**THIRD RESPONSE TO REQUEST FOR ADDITIONAL INFORMATION
PERMIT TO OPERATE COMPOSTING FACILITY
PERMIT TO CONSTRUCT LEACHATE TREATMENT FACILITY
PERMIT TO OPERATE RESOURCE RECOVERY FACILITY
WASTE TIRE GENERAL PERMIT
AND
PERMIT TO MAINTAIN CLOSED CLASS I SANITARY LANDFILL
PREPARED FOR**

**BOARD OF COUNTY COMMISSIONERS
DEPARTMENT OF PUBLIC WORKS
222 EAST McCOLLUM AVENUE
BUSHNELL, FLORIDA 33513**

October 2, 1992

RE: SUMTER COUNTY SOLID WASTE FACILITIES
PERMIT NO.:

**APPENDIX B
GROUNDWATER ELEVATION MAPS**

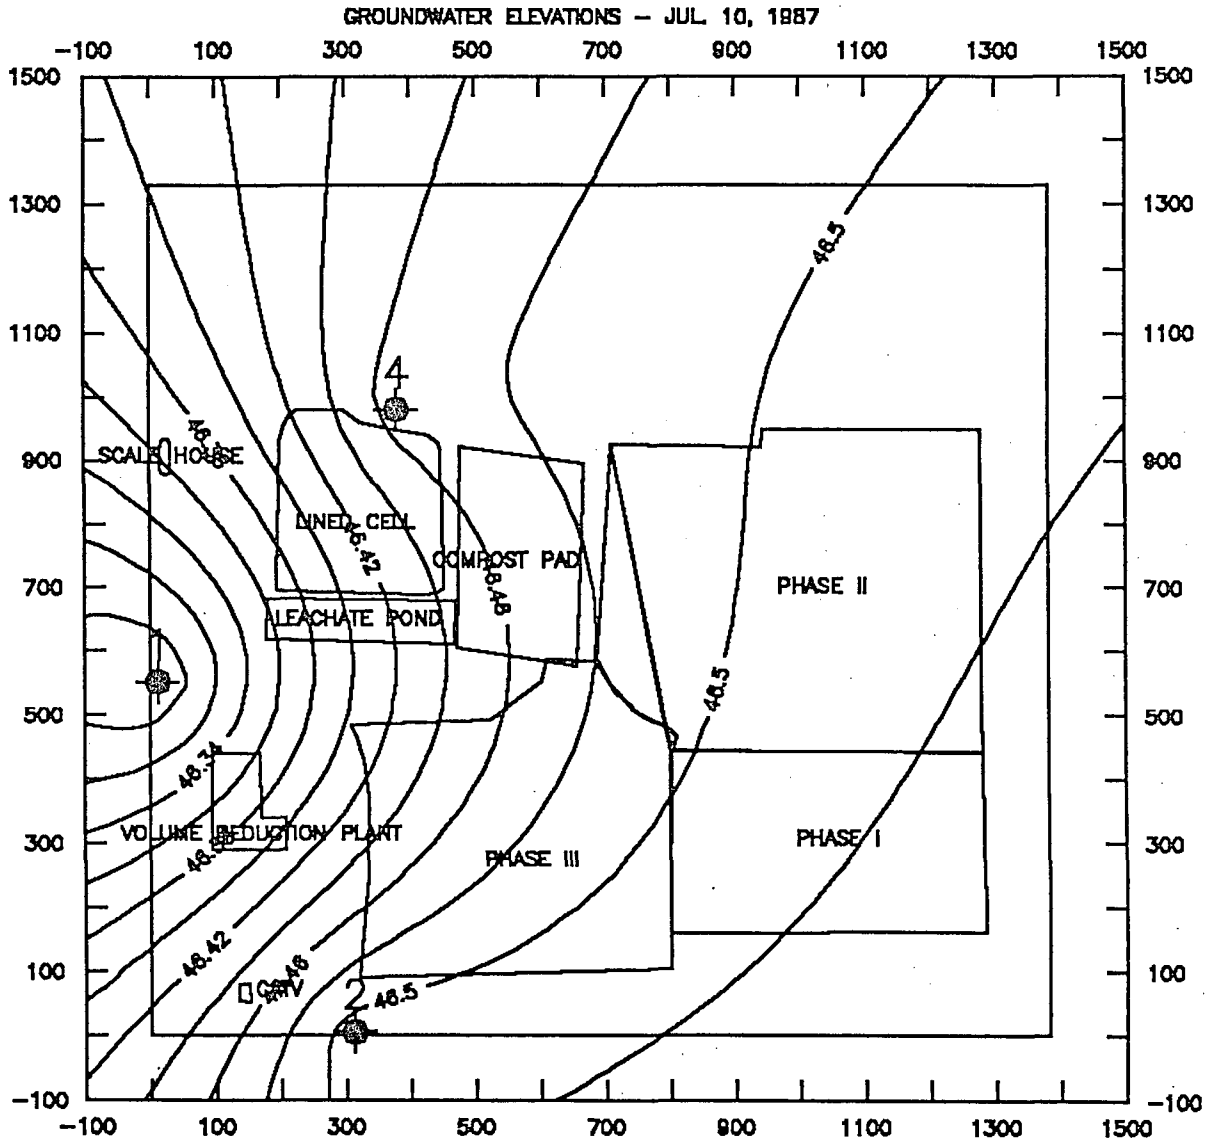
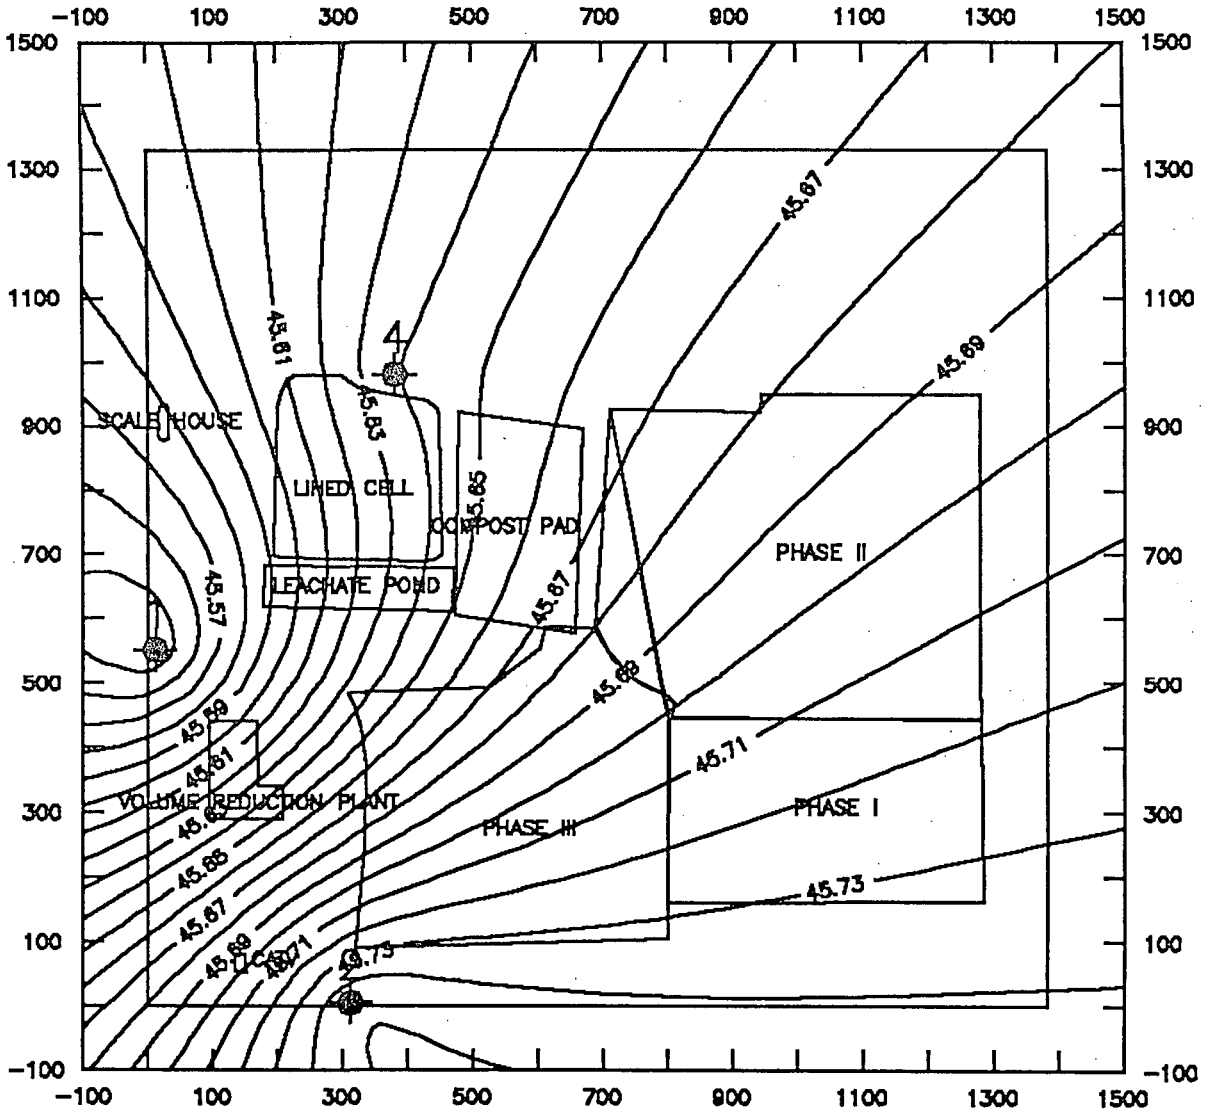
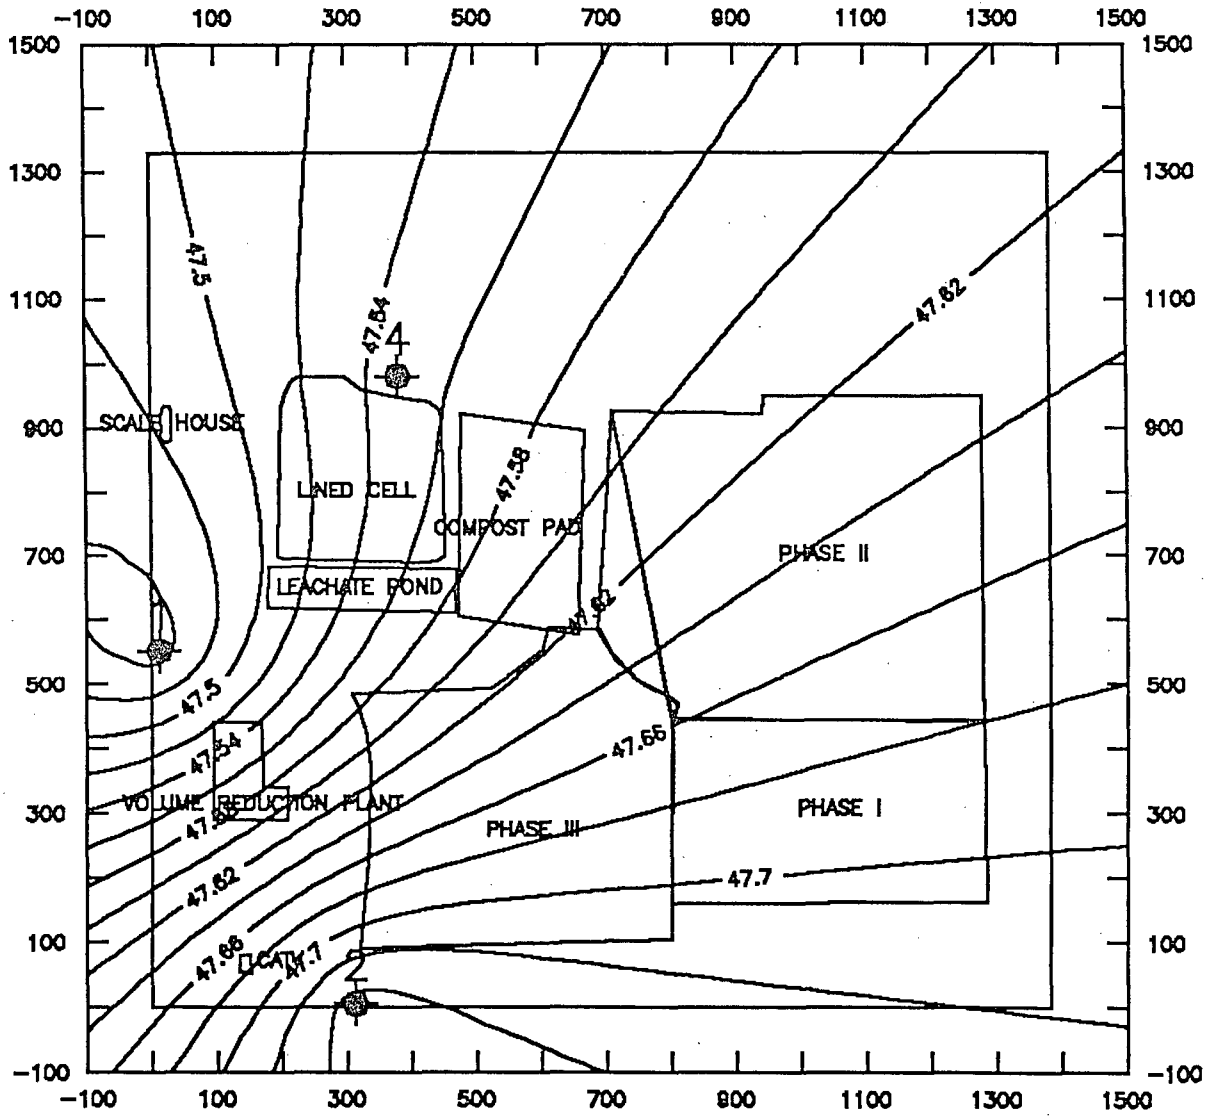
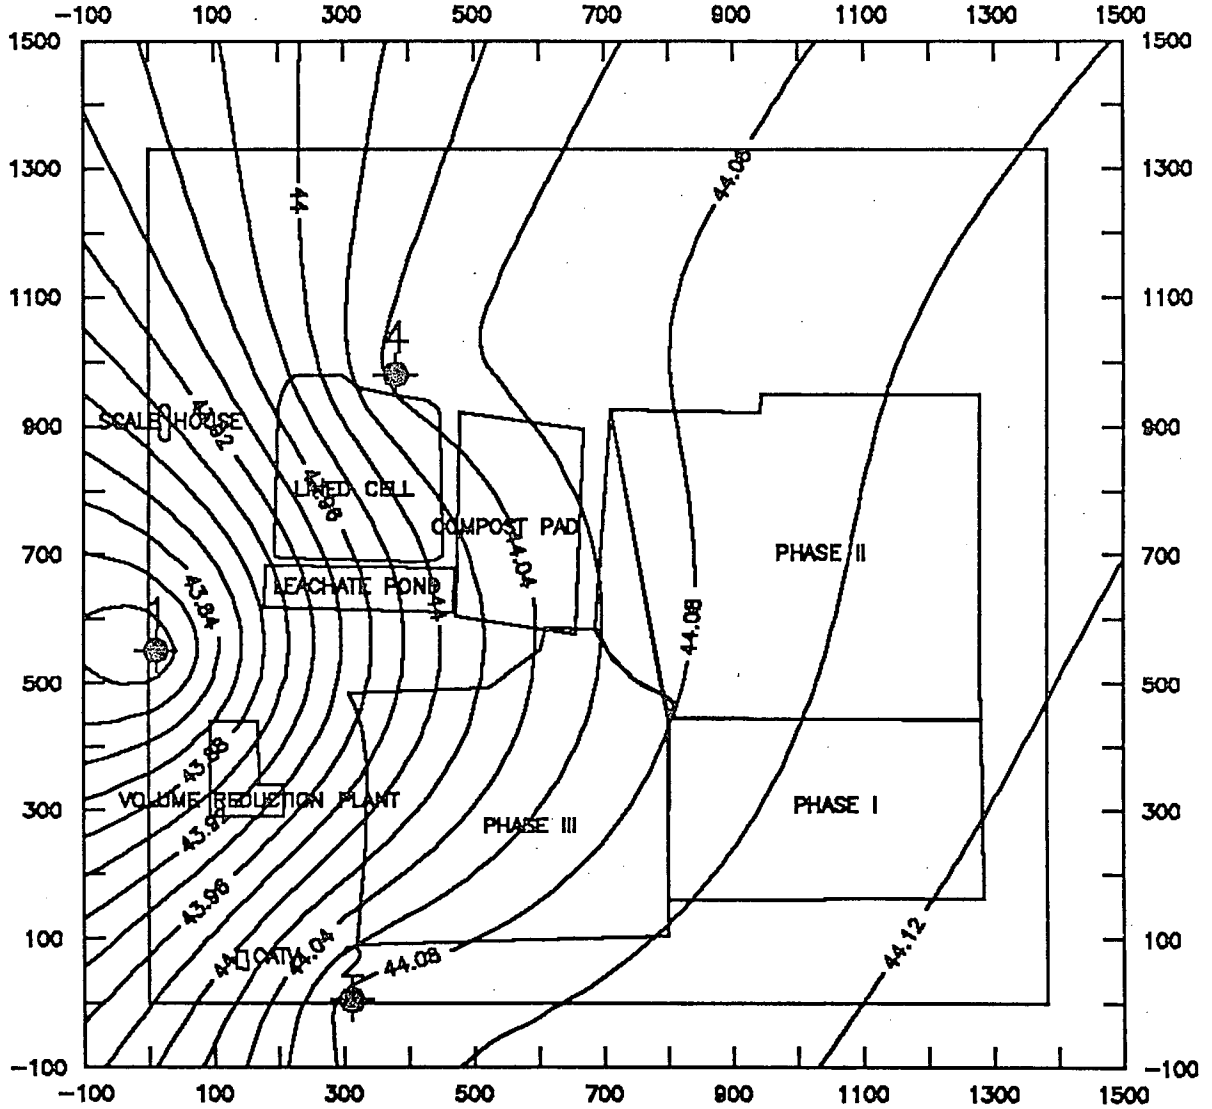
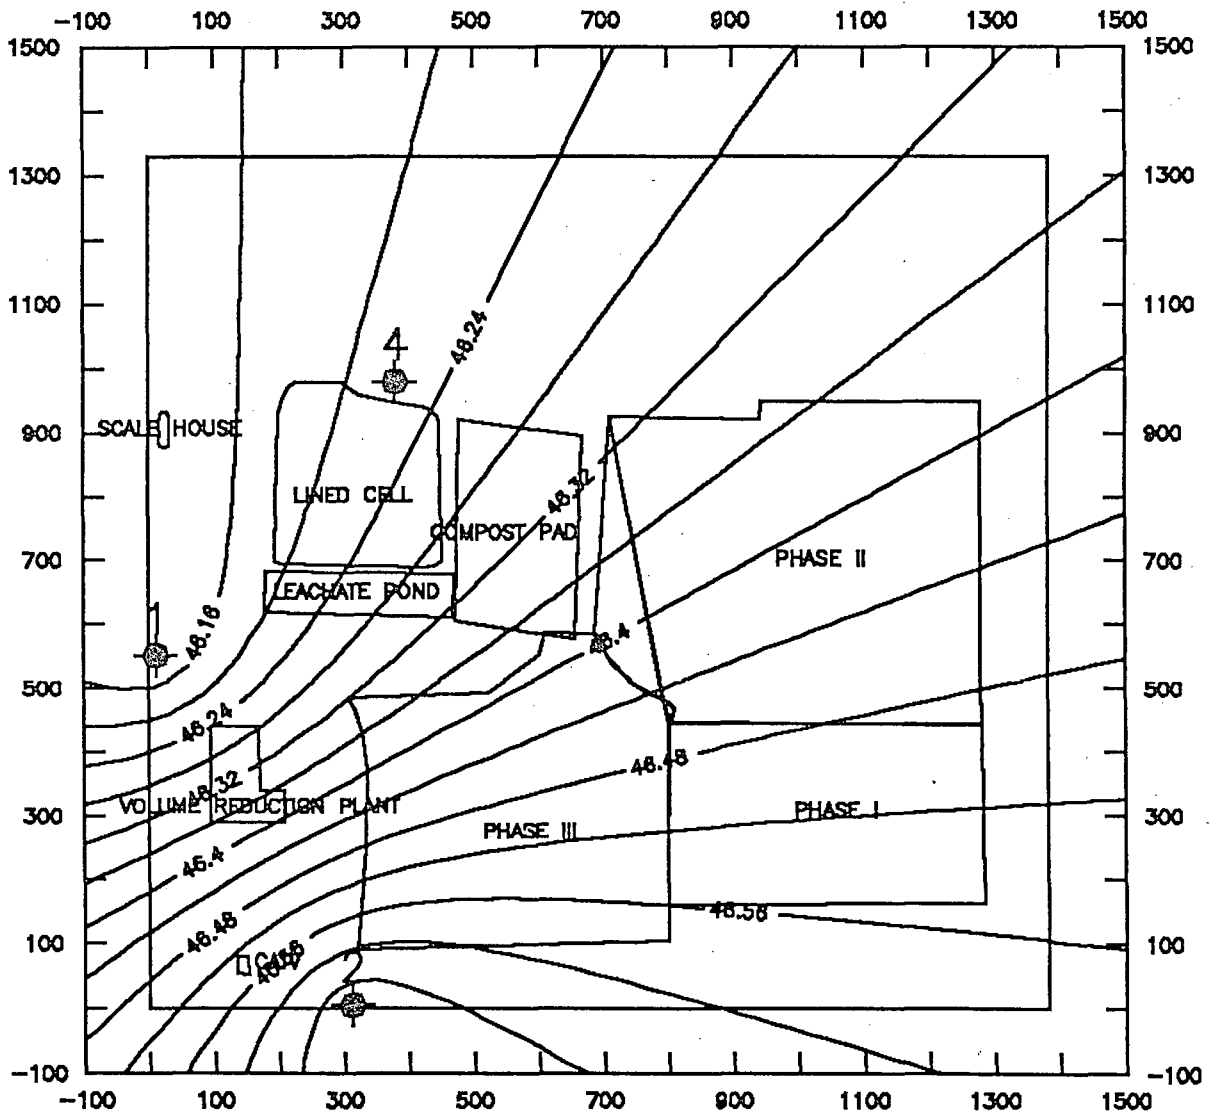
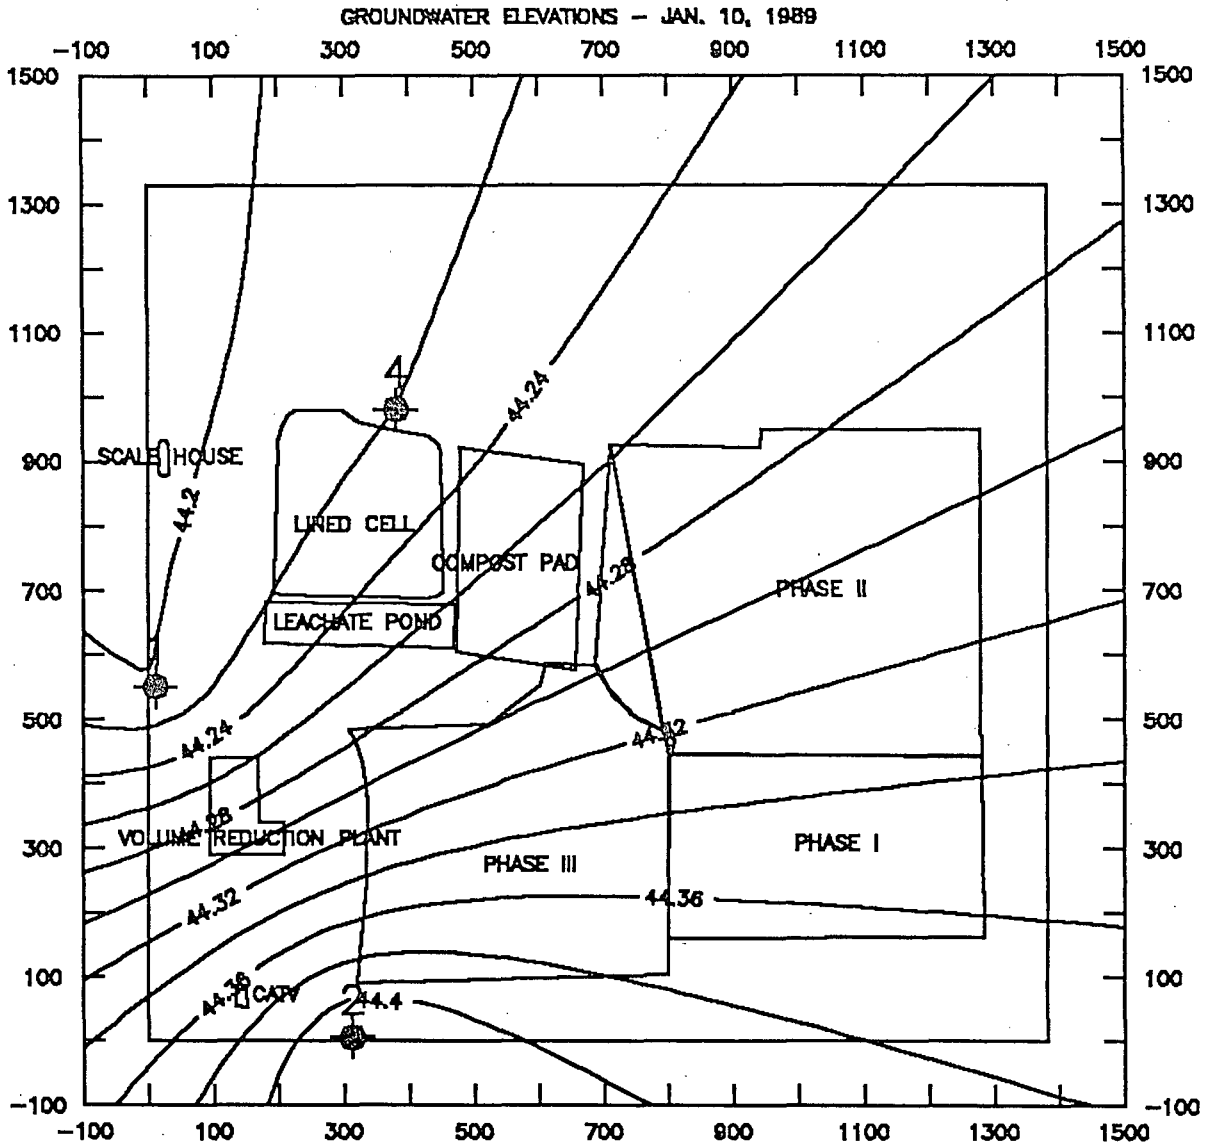
- 3.2. The groundwater Elevation Contour Maps in Appendix C do not illustrate the Phase I, Phase II, and Phase III-Class I landfill areas, but it appears that there are no downgradient monitor wells to the south and southeast of the closed Class I areas. Recommendations for monitor wells in these areas should be proposed.

- 3.2. The Groundwater Elevation Maps previously submitted did not illustrate the Phase I, Phase II, and Phase III-Class I landfill areas. The maps have been redone showing these features and are presented in Appendix B.

It is our opinion that the direction of groundwater flow determined by the contours does not represent the regional groundwater flow direction but rather a groundwater fluctuations caused by stormwater runoff from the closed cells recharging the surface aquifer and the possible partially confined Floridan Aquifer at various locations of the stormwater management system. The data from MW-7 seems to be extreme and when used causes the apparent direction of groundwater flow to be toward the south.
